Re: Response to Request for Review for “Tradewinds Methane Extraction and Power Generation Project” (Ref. no. 1285)

Requests:

Figure 1: Layout Diagram of Wastewater Treatment Facilities before Implementation of CDM Project

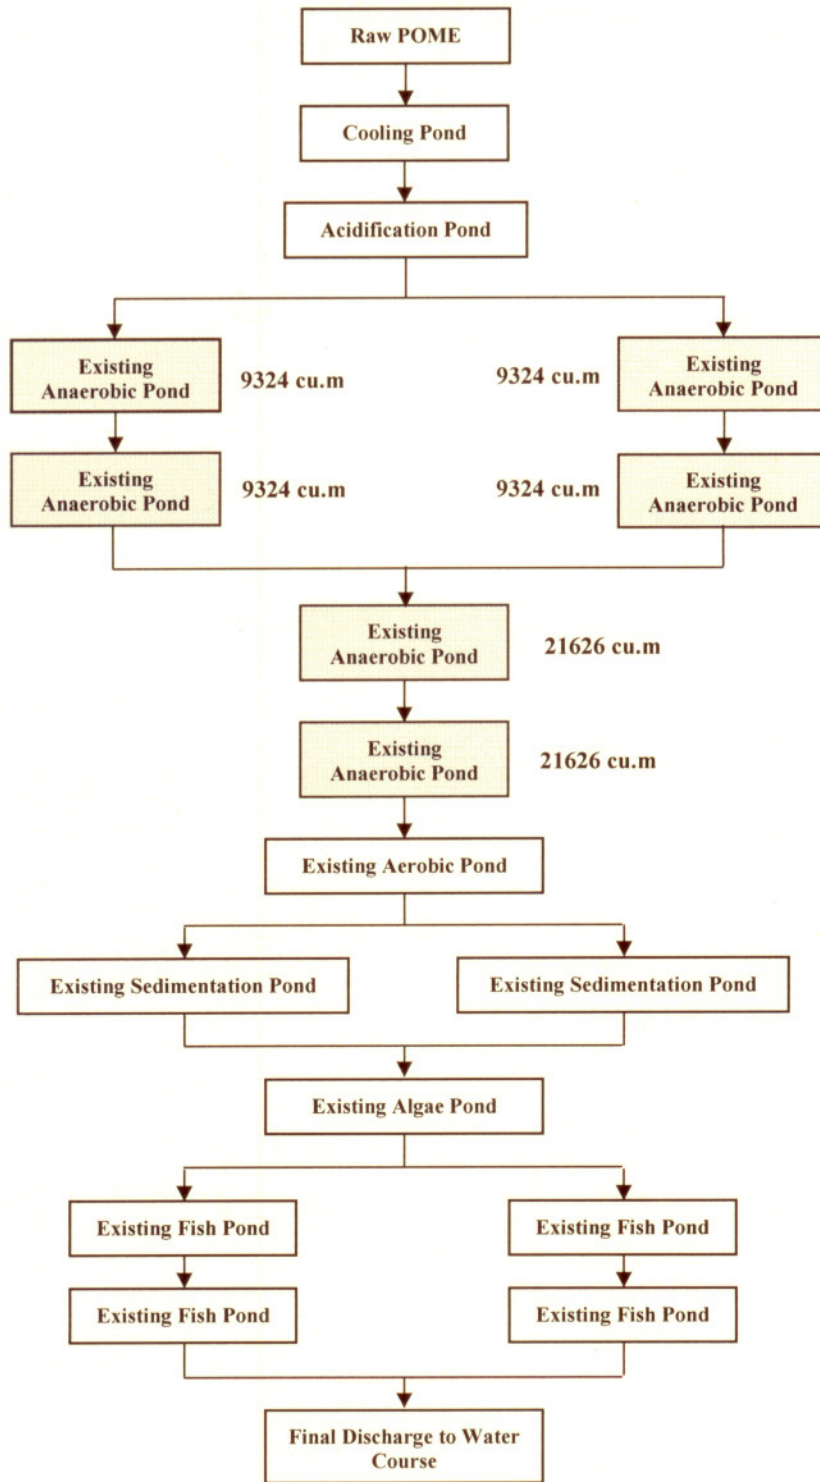
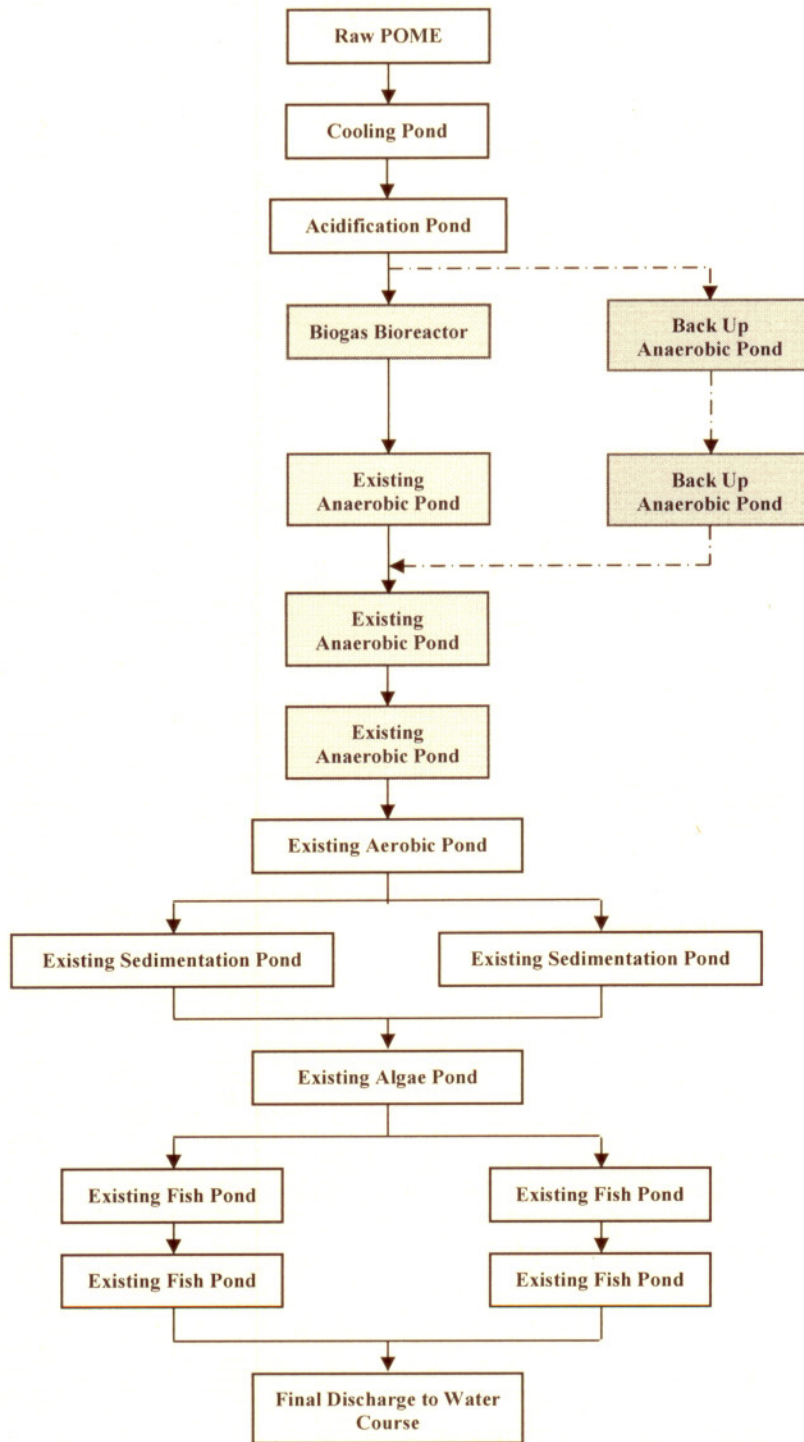
4. The PP/DOE must provide further justification how following requirement of the approved methodology AM0022 has been met considering that project activity is covering up an existing open lagoon for collecting biogas: “The project activity foresees the introduction of a new anaerobic treatment facility into an existing lagoon-based treatment system for industrial organic waste water treatment. The output of partially treated water of the new anaerobic treatment facility will be fed into the existing lagoon system.”

The anaerobic reactor that has been installed is a so called “in ground reactor” and is constructed as a pond with a cover and the equipment necessary to capture the biogas. Effluent from the anaerobic reactor will flow into the existing lagoons system as described in the Written Approval* (Attachment 10 – Written Approval Application to Dept of Environment, Sarawak).

Because of the fact that the anaerobic bioreactor is considered as a new activity the project partners had to apply for a new approval. A written approval for this new activity has been received (Attachment 11 – Written Approval issued by Dept of Environment, Sarawak).

Refer Figure 1 and 2 for Layout Diagram of wastewater treatment facilities before and after implementation of CDM project activity.
